PLAN COMMISSION

July 11, 2017

PROJECT: Sign Plan Review – Froedert & Medical College of Wisconsin (Neil Jensen)

PROJECT: Plan Review – Joe Tikotzky, Villa Healthcare

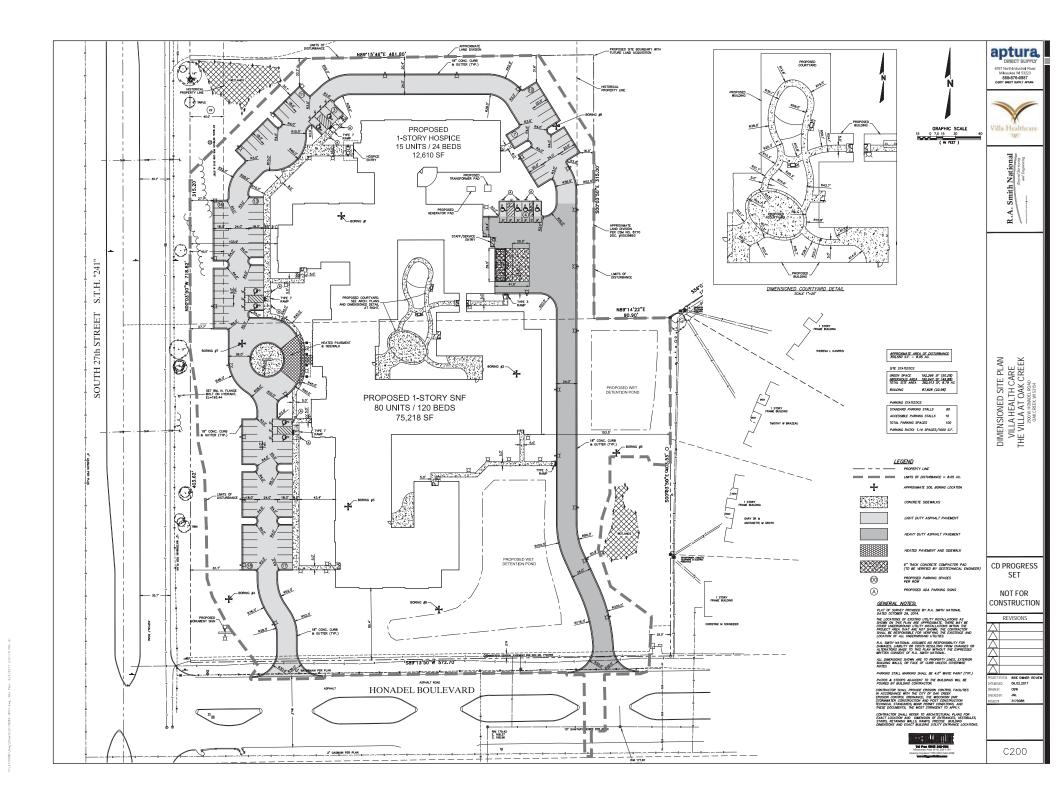
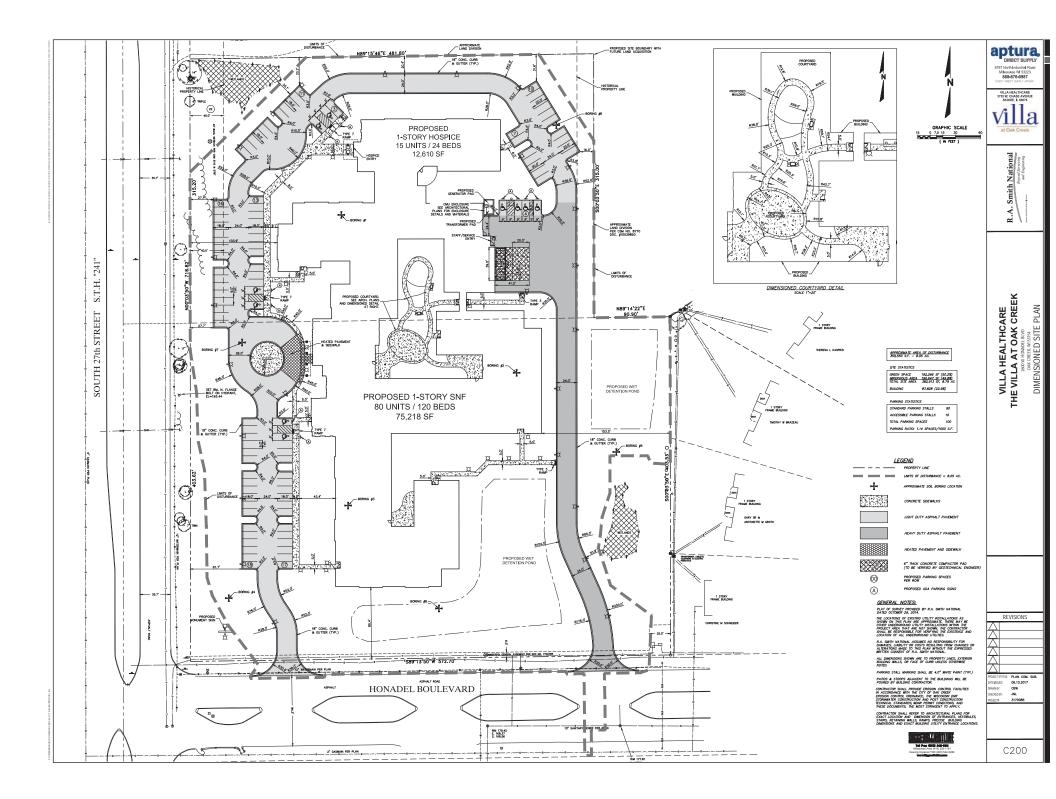
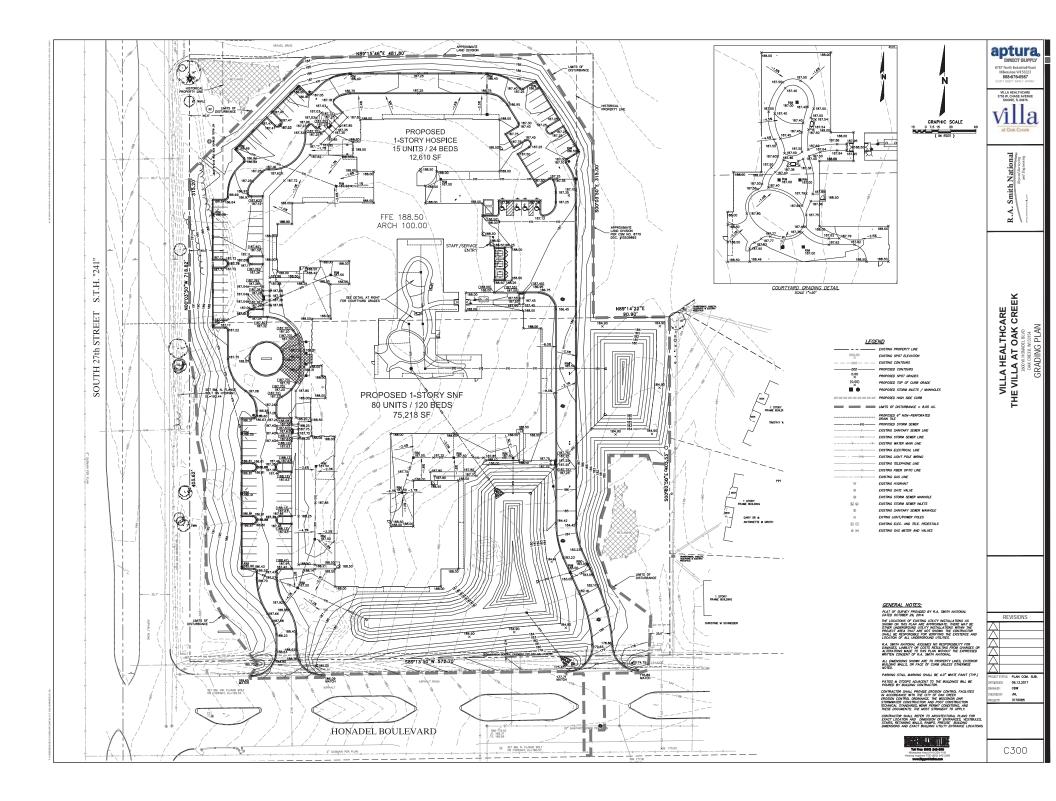
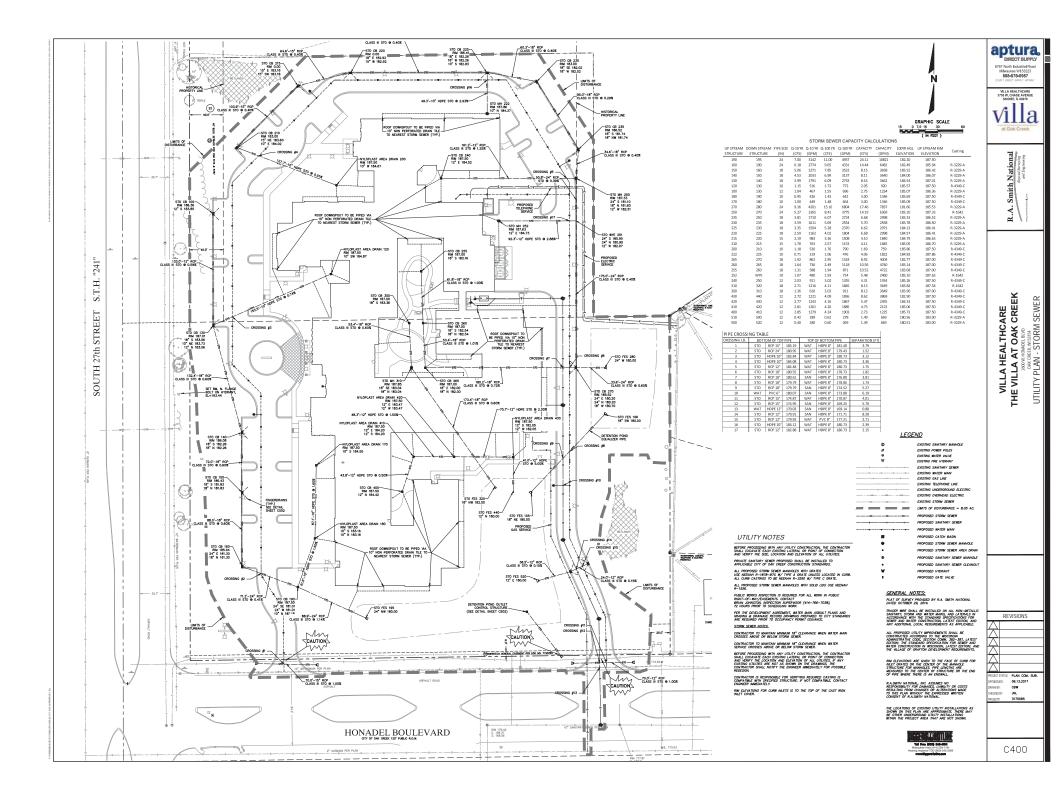
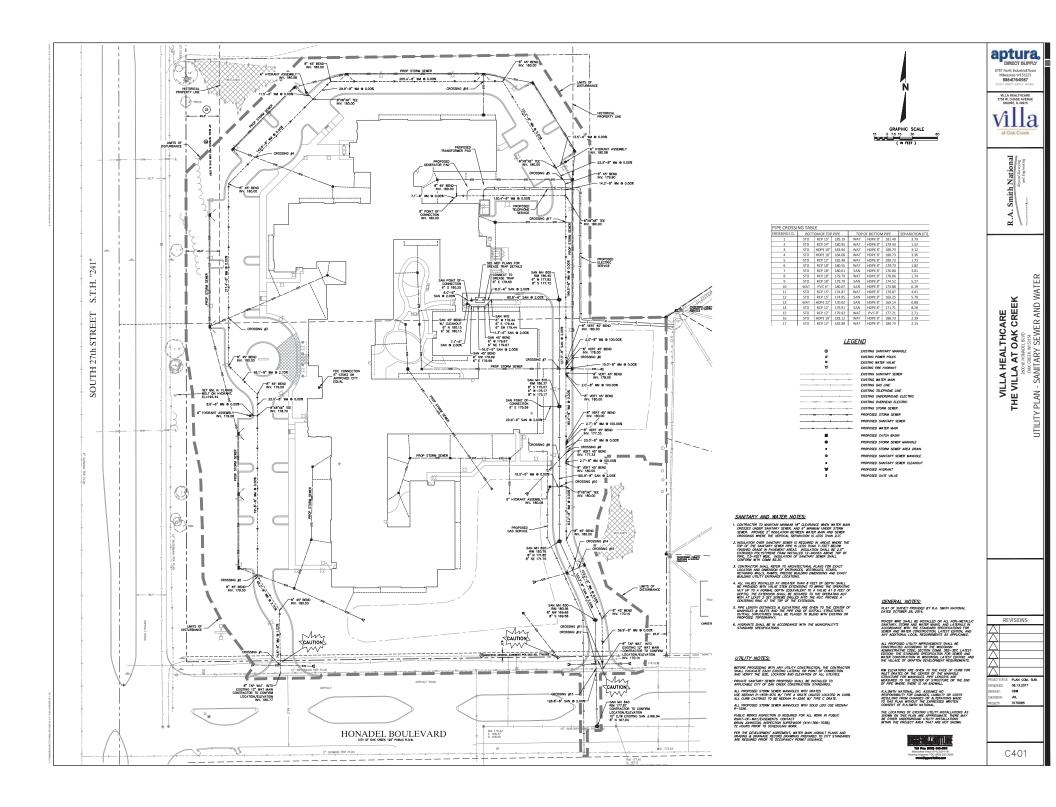
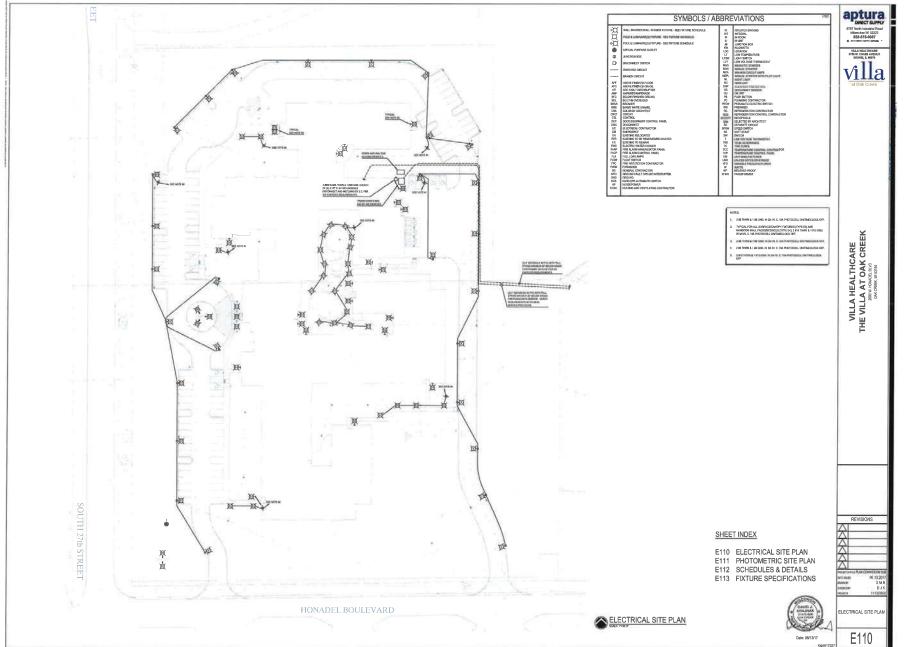
Landscaping plans have been submitted showing vegetative screening along the east property line, and plantings around the property. As of writing this report, additional information for the proposed landscaping was forthcoming. Staff will continue to work with the Applicant's consultant should modifications be required. Final approval of landscape plans are recommended to be approved by the Director of Community Development as stated in the conditions above.

In response to a question from the Oak Creek Water and Sewer Utility regarding location of utilities, the Applicant's consultant indicated that they will be coming from Honadel Boulevard. The consultant also confirmed that the utilities will be private.

- 2. See updated landscape plans for the plant list and coverage chart.

3. Regarding the existing trees, the trees along 27^{th} street, west of the property line are shown to remain. There appear to be existing pine trees within the property were not individually surveyed. This survey will yet need to be scheduled to determine the diameter. Please confirm if this issue can be addressed at staff level. Our civil engineer had requested additional detail from the city forester on Thursday June 29^{th} to coordinate – still pending.

4. We did coordinate our utility connections early on with Brian Johnston at the City. We are bringing them all in from Honadel Blvd. and it is understood that they will be private.

5. I contacted Brian Johnston and he responded below.
